API WELL #	Well Name	Well #	Operator Name	Type	Stat	County	Surf_Owner	UL	Sec	Twp	N/S	Rng	W/E
30-039-25382-00-00	BROWN	200	THOMPSON ENGR & PROD CORP	G	E	Rio Arriba	F	N	31	29	N	4	W

SUNDRY NOTICES AND REPORTS ON WELLS

P & A Procedure for
Thompson Engineering
Brown #200

THOMPSON ENGINEERING
 BROWN #200
 SEC. 31, T29N, R4W
 RIO ARriba Co., NM.
 API # 30-039-25382

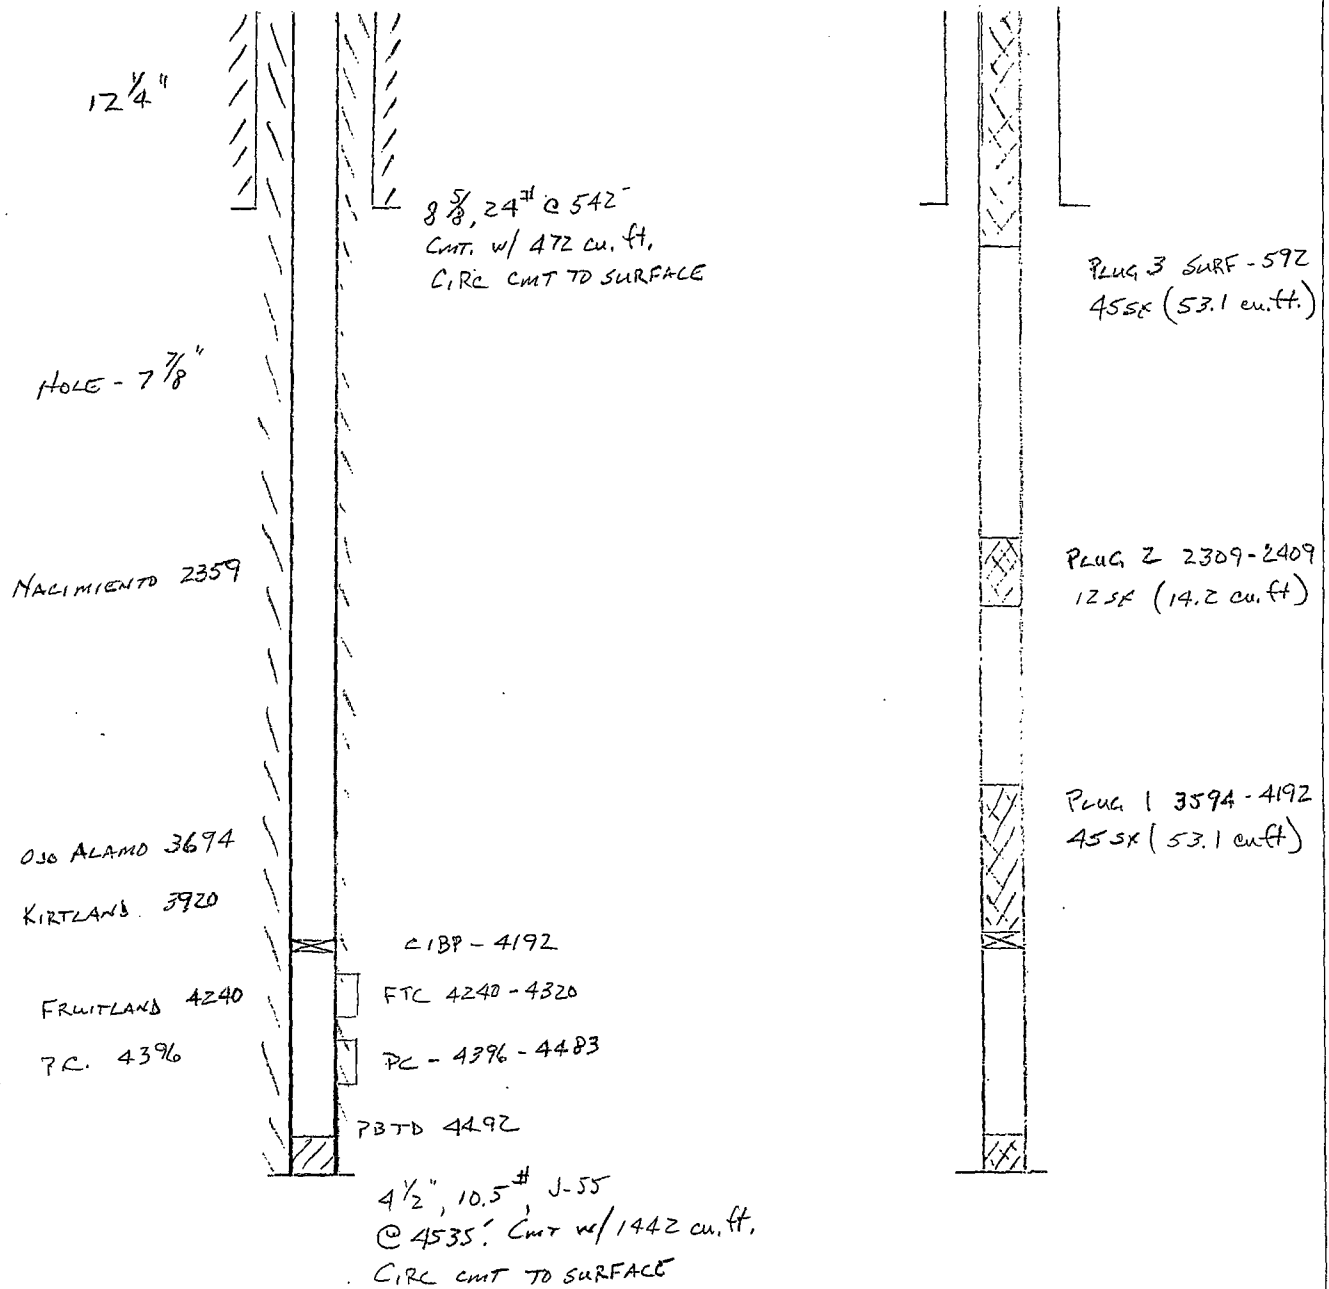
Add PC plug above PC perfs (4396 - 4483)
